Access Compliance Report Public Rights-of-Way (Curb Ramps)

Main Street: N/A		Cross Street: RED_HILL_AVE		Location: N	
ADA ID: RPRK220107114556	Ramp Type: Type 6 - Directional 1	Initial Pass/Fail: Pass	Overall Compliance: No	Severity Score: 12	
Codes/Mitigation Info/Possible Solution			Field Measurements/Component Compliance

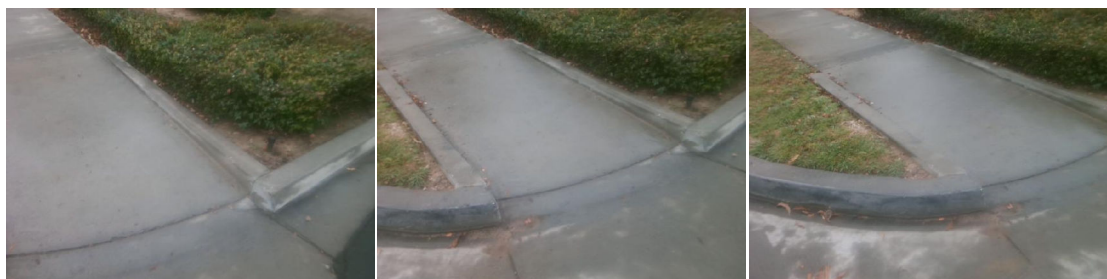
Compliance	Description	Data	Compliance	Description	Data
N/A	Ramp Length (in)	115	Yes	Flare Type LT	
Yes	Ramp Width (in)	58			Curbed2
Yes	Ramp Run Slope (%)	2.2	N/A	Flare Slope LT (%)	N/A
Yes	Ramp Cross Slope (%)	1.7	N/A	Flare Traversable LT	N/A
No	Grade Break	No	Yes	Flare Type RT	
N/A	Grade Break Slope (%)	N/A			Curbed2
N/A	Grade Break Cross Slope (%)	N/A	N/A	Flare Slope RT (%)	N/A
	Addl Para Ramp Left?	No	N/A	Flare Traversable RT	N/A
	Addl Para Ramp Right?	No	No	DWS Provided	No
N/A	Landing Present	Yes	N/A	DWS Contrast	N/A
Yes	Landing Length (in)	83	N/A	DWS Length (in)	N/A
Yes	Landing Width (in)	58	N/A	DWS Full Width	N/A
Yes	Landing Run Slope (%)	1.3		DWS Offset Type	N/A
Yes	Landing Cross Slope (%)	1.8	N/A	DWS Left Offset (in)	N/A
N/A	Landing Movement Obstructed?	No	N/A	DWS Right Offset (in)	N/A
	Landing Movement Type	N/A			
N/A	Landing Shared	No			
N/A	Marked Crosswalk 1	No	N/A	Clear Space	N/A
	Crossing 1 Direction	NE	N/A	Clear Space To Crosswalk (in)	N/A

Marked Crosswalk 1 Width (in)	N/A			
N/A	Ramp Inside Crosswalk 1	N/A			
	Crossing 1 Slope (%)	3.1			
	Crossing 1 Cross Slope (%)	0.7			
Yes	Gutter Ponding	No	Yes	Curb Slope	5
Yes	Gutter Lip Height (in)	0		Road Run Slope (%)	N/A
Yes	Gutter Run Slope (%)	4.6		Road Cross Slope (%)	N/A
Yes	Gutter Cross Slope (%)	1.9		Parallel Ramp Side	N/A
Yes	Overall Surface Condition	Acceptable	Yes	Perp Joint Present	Yes
	Cross Gutter Present?	Yes		Spandrel Present?	Yes
	Replace Cross Gutter?	No		Replace Spandrel?	No

Possible Solutions:

Remove & Replace Entire Ramp.

R304.5.2, R305, STD 1115
